| Title of Change: | Update Notification for PB21550X - Conversion of SMC packaged devices to the 403AC case outline. |

Description and Purpose:

Figure 1

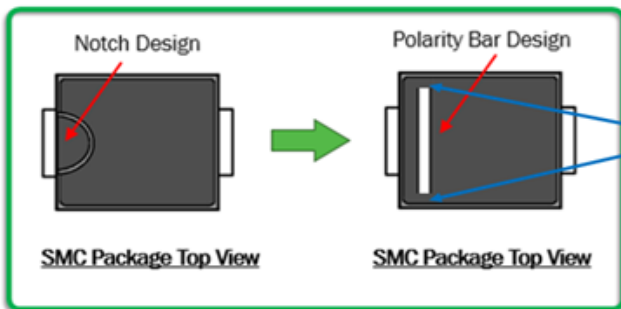
This Update Notification announces that the case outline of SMC packaged devices will migrate from 403-03 to 403AC. Case outline 403AC includes the change from the legacy polarity notch to the industry standard polarity band and incorporates minor dimensional changes. The dimensional changes provide clarification of lead forming details and will allow ON Semiconductor to ultimately migrate products obtained from the recent Fairchild acquisition to a single common case outline.

PB21550X was previously released to announce that ON Semiconductor Malaysia is converting the diode polarity identification for SMC packaged devices from a notch molded into the epoxy body of the device to a laser marked polarity band.

The change will align ON Semiconductor Malaysia with the current industry standard for SMC polarity identification. The details of this change are displayed pictorially in Figure 1 below. An example device showing both the legacy notch that will be eliminated and the polarity band that will be replacing it is shown in Figure 2.

Band does not extend to edge of epoxy body
